# TECHNICAL BULLETIN

**Product:** Hi-Motion II

**Purpose:** To ensure compatibility with SHED HDX by changing the capacitor to a bi-polar type.

**Figure 1 – E/O & O/E board**

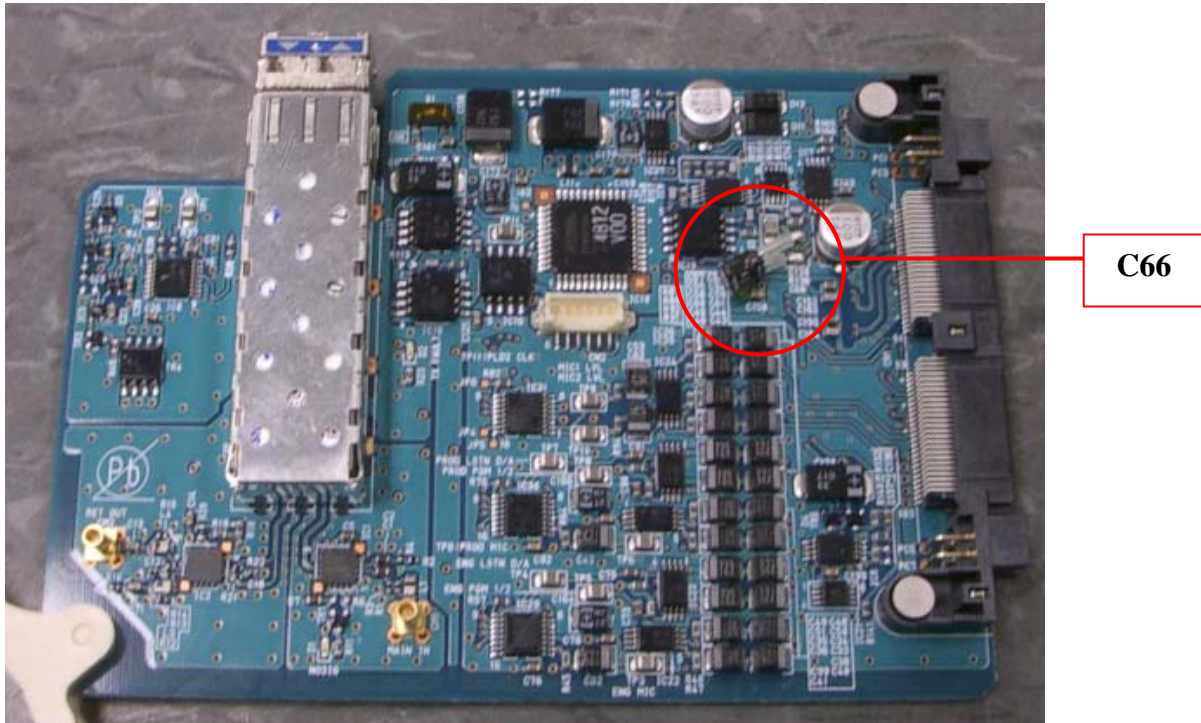
**Symptom:** When the camera is connected to a Telecast SHED HDX the 1K load of the HDX causes a capacitor on the E/O & O/E board to be reverse biased, which causes the voltage on one low voltage standby line to increase over time, sometimes exceeding the detection range for an Ikegami type camera. The HDX may then shut down or power cycle. This capacitor will become damaged over time, further increasing the likelihood of voltage detection errors in the HDX.

**Instruction:** Remove the E/O & O/E board taking care of the two fiber and two coax leads connecting to this board. Remove capacitor C66 (15uF/16v) and replace with a 10uF/10v bi-polar capacitor, part number UMP1A100MDD. Since the bi-polar replacement capacitor is not surface mount type, it should be mounted on its side using a silicone adhesive to maintain position. Refer to figure 1 for part location.
